AIRWORTHINESS DIRECTIVE

TYPE AFFECTED: ASK 21 - All serial Nos. up to 21345 (inclusive)

1. Inspection of rudder pedals
2. Flight/Maintenance manual amendments
3. Inspection/replacement of airbrake fuselage mounted bellcrank
4. Inspection/modification of the rear canopy hinge

ASK 21
Technical Note
No.20

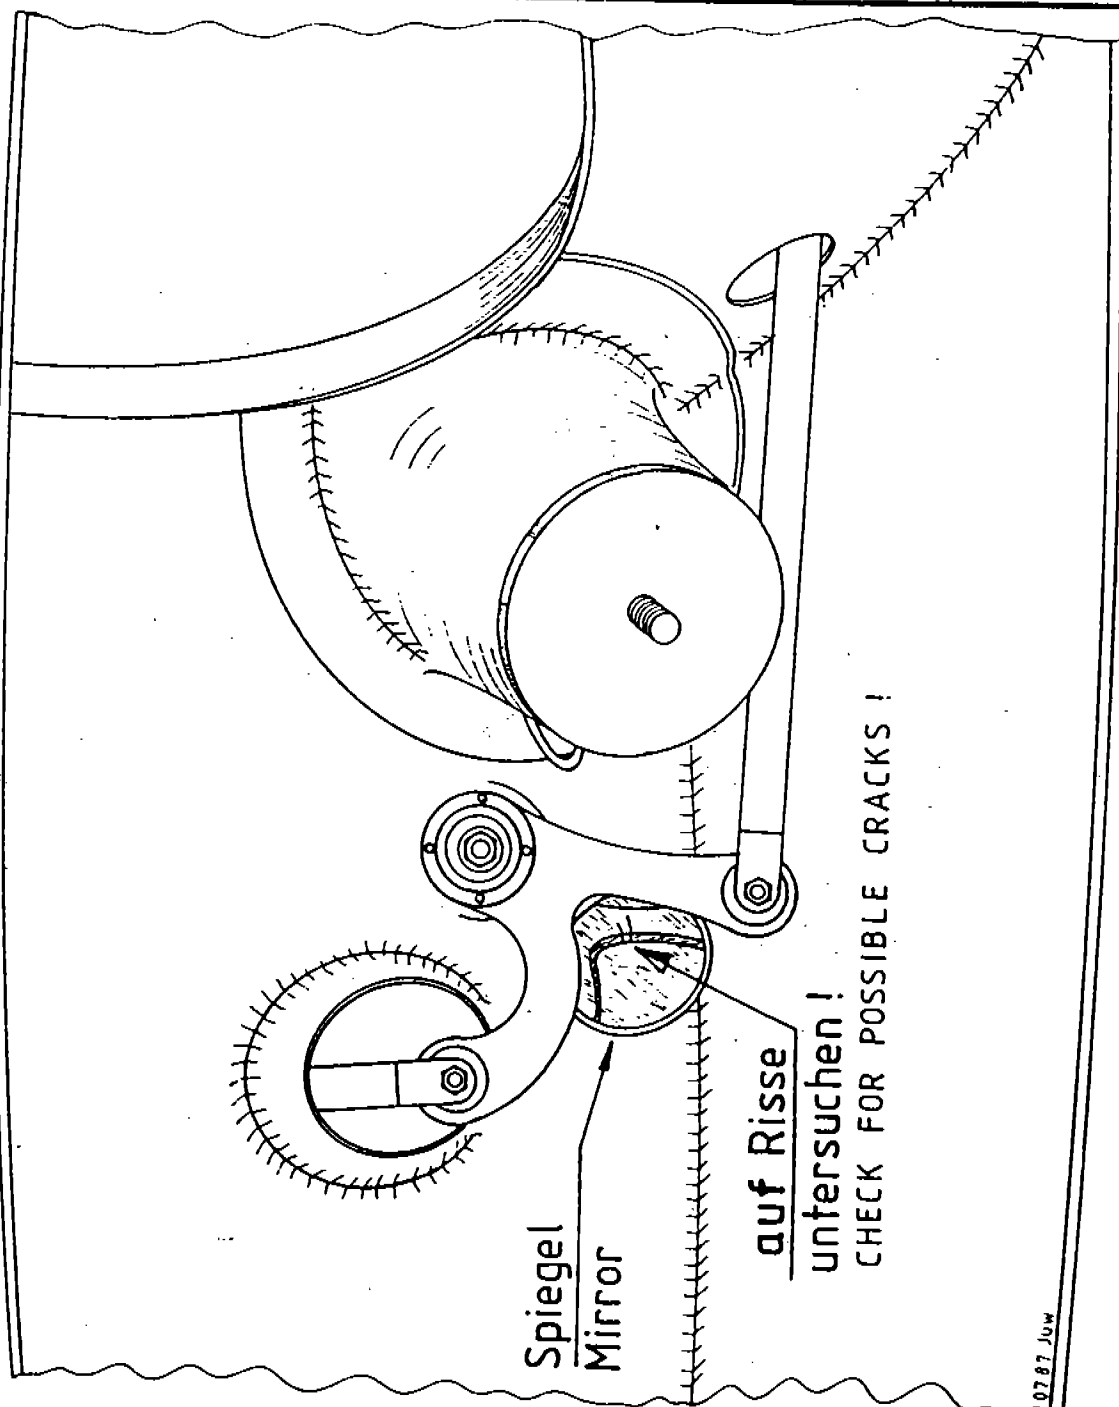
3.1 Prior to the next take-off it must be checked if the air-brake bellcrank in the fuselage shows cracks or deformations --> see Fig. 1.

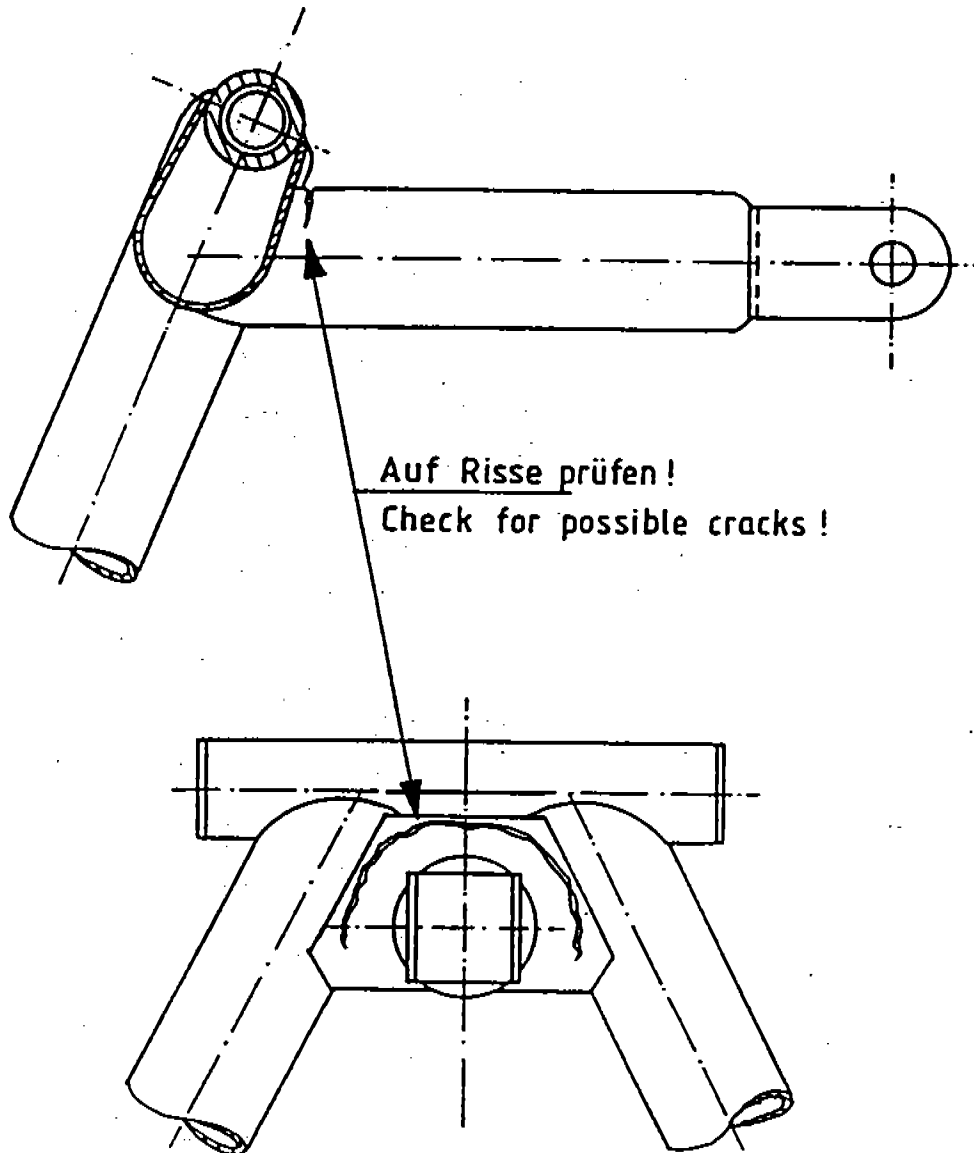
Replace the original factory fitted airbrake system bellcrank with a new bellcrank and bracing complying with Drawing 210.43.S5.

3. In two cases the pre-flight checks on the ground with the ASK 21 showed the airbrake bellcrank in the fuselage (210.43.0005) cracked --> see Maintenance Manual p.16, item 5 (for the US-edition of the manuals see the corresponding "Instructions For Continued Airworthiness" p. 19, item 5).

3.2 If cracks or deformations are found, the airbrake bellcrank must be removed prior to the next take-off and the new bellcrank with an additional support must be fitted --> see drawing 210.43.S5.

3.3 If no damages are found, flight operation can be continued for the present. Until the next annual glider re-inspection, however, at the latest by April 30, 1988, the new bellcrank in the fuselage (210.43.0005) must be fitted.

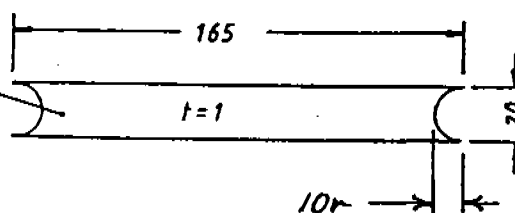
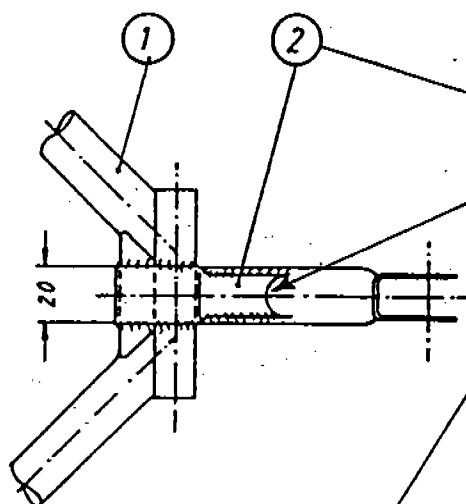
Check rear canopy hinge for cracks in accordance with Drawing 210.12.S5. (Disregard if hinge is modified to Drawing 210.12.S5 Sheet 2).

4.1 Prior to the next take-off it must be checked if the rear canopy hinge shows cracks --> see drawing 210.12.S5.

4.2 If cracks are found, prior to the next take-off the rear canopy must be disassembled and the canopy hinge must be reinforced as shown on drawing 210.12.S5.

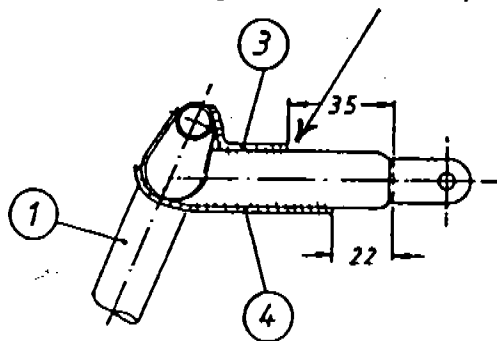
NOTE: DO NOT WELD ACROSS THE
ENDS OF THE REINFORCING
STRIPS.

Welding required to modify the rear canopy hinge is to be carried out by a DoTC licensed welder or a GFA authorised welder. The welder is to record the work by logbook entry.
